Technical Memo No. 101

Lifestyle™ Sliding Window 00-524BL Centre Locking Latch

New Lockable Window Latch

Lifestyle™ Sliding Window Sections with latch

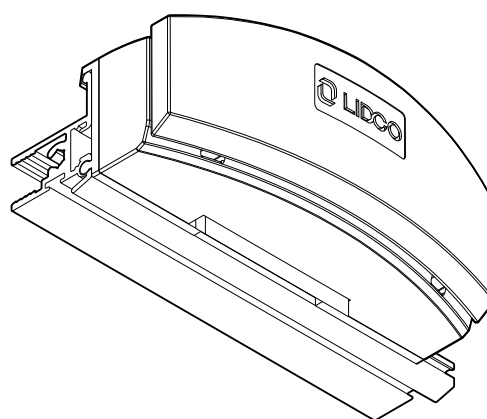
Due to customer feedback and demand Lidco announces the addition of a new Centre Locking Latch (00-524BL) for the popular Lifestyle™ Sliding Window (112 System). The new lockable latch will also work on the old Lidco 110 System for those fabricators still using this system.

The Centre Locking Latch is fitted to the new interlocking style section (LSS-164) and catches on the alternative glazing bead (LSS-165). The cutting formula remains the same with either interlocking style. The problem of limited clearance between the jamb latch and reveal is overcome with this new latch.
